TECHNICAL SERVICE BULLETIN INSTRUCTIONS

TSB #: SB-62

Models Involved: 2022 Allegro Open Roads, 32FA

Purpose: To provide instructions on how to reverse the hydraulic lines on the bed slide of the 32FA so the slide override will work properly.

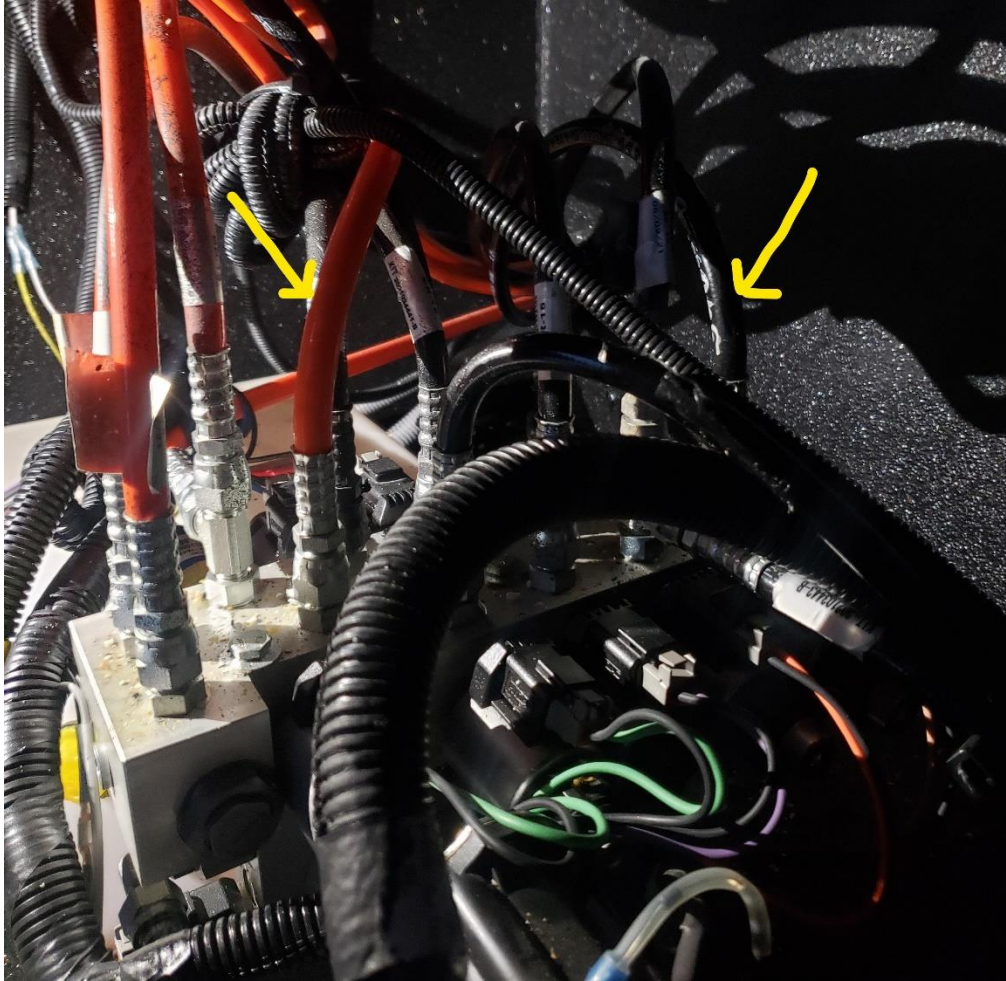
3. Locate the orange and black hydraulic lines labeled "BED SLIDE." (This will be the fourth orange line and the fourth black line.)

4. Using the 11/16" wrench, swap these lines. (Once the fitting is loose and before you remove the line from the connection point, wrap the rag around the connection point, and then remove the line. This will help contain the remaining fluid to a confined area.)
